**ELECTRICAL—AFTERMARKET ACCESSORIES  
INOPERATIVE OR NOT OPERATING AS DESIGNED—  
POLICE INTERCEPTOR MODELS BUILT BEFORE  
5/23/2002 ONLY**

**Article No.  
02-15-1**

**FORD: 2003 CROWN VICTORIA**

Figure 1 - Article 02-15-1

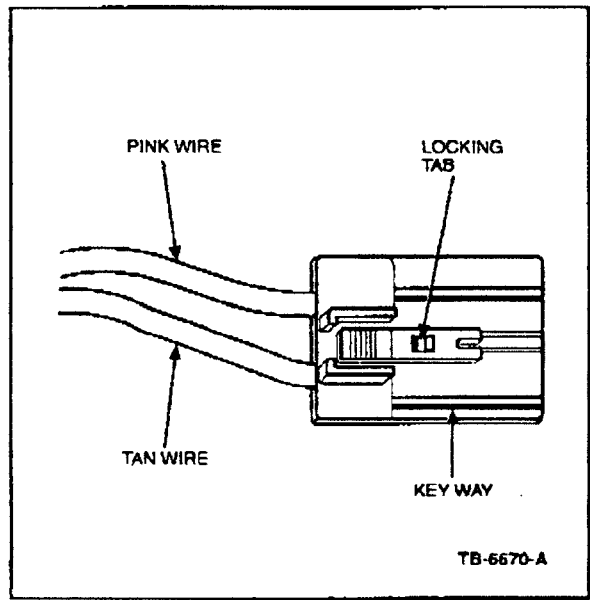
Some 2003 Crown Victoria Police Interceptors built before 5/23/2002 may have the tan and pink wires into electrical connector C2232d in the incorrect pin locations. These wires supply power to the optional police front power distribution box. The tan wire is hot at all times; whereas, the pink wire is hot with ignition in run. This may cause aftermarket police accessories intended to have power only with key on, to be powered at all times. Accessories intended to have power at all times, would have power only with key on.

Locate connector C2232d under the passenger side instrument panel. This connector supplies power to the optional police front power distribution box. Compare the wire locations to those shown in Figure 1. If the wires are in the incorrect pin locations, refer to the following Service Procedure for details.

5. Grasp the connector with one hand and use the screwdriver to depress the locking pin inside the connector to release the terminals.
6. Switch locations of the terminals to match Figure 1.
7. Ensure that the terminals are locked into place by tugging lightly on the wires.
8. Replace the red locking retainer.
9. If previously removed:
  - a. Reconnect the three connectors to the back of the power distribution box.
  - b. Hang PDB back on to bracket.
  - c. Secure the box to the bracket with the two 7mm screws.
  - d. Torque the screws to  $13 \pm 2$  Lb-in. ( $1.5 \pm 0.2$  N\*m).
10. Reconnect battery.
